Clarification Note # 1

Request for Quotation (RFQ) No. PR 621169 - Supply and delivery of equipment and accessories to create a multimedia distant-learning classroom in the Palladin Institute of Biochemistry (Kyiv, Ukraine)

LOT 4 - Air conditioners and installation services

Room 105 (Training Room) – Place of AC external unit installation, street view

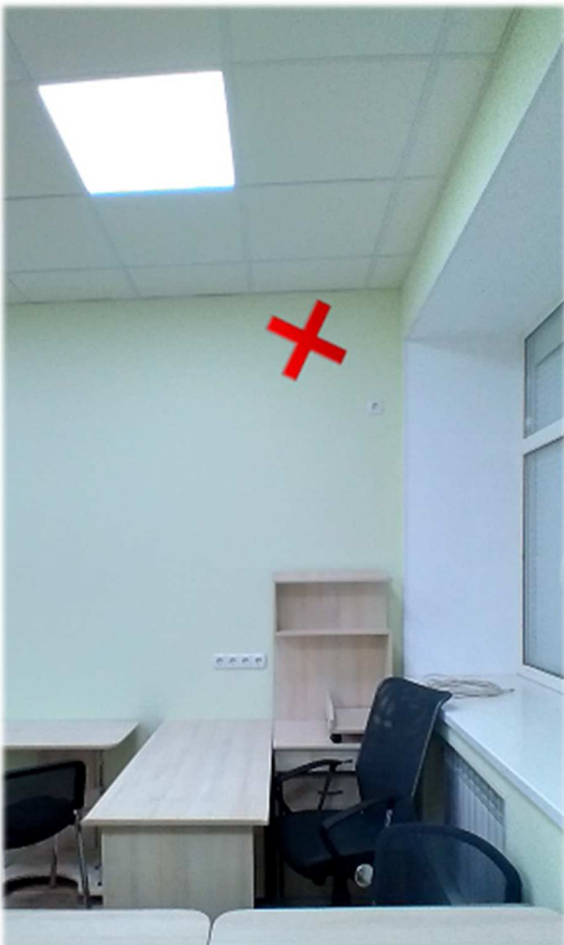
Question 1: To understand the upcoming scope of work and, accordingly, its cost, could you clarify the following:

- 1) Locations of outdoor and indoor units of air conditioners - to determine the length of the Freon line.
- 2) Place of drainage outlet (bathroom, street, storm drain, etc.).
- 3) Is there access from the window to the installation site of the outdoor units or is it necessary to order lifting mechanisms or invite industrial climbers?
- 4) Should power supply be from the panel or from the nearest outlet?
- 5) What is the length of the decorative box for the Freon line (if necessary)?
- 6) Any other additional work or installation conditions.

Answer 1: The answers are below. Pictures with indicated places of installation are provided in Annex A at the end of this document.

- 1) See Annex A, the places of installation of outdoor and indoor units of air conditioners are marked with a red cross.
- 2) Place of drainage outlet – street.
- 3) Installation is on the 1st floor, there is an access and possibility of using a regular staircase.
- 4) Power supply from the panel (electrical distribution box). In room 105, there is a panel in the room, in 103 - in the corridor. Electric cable shall be covered with decorative box.
- 5) Decorative box for Freon line is not needed.
- 6) Power supply should be installed with the cable from the panel.
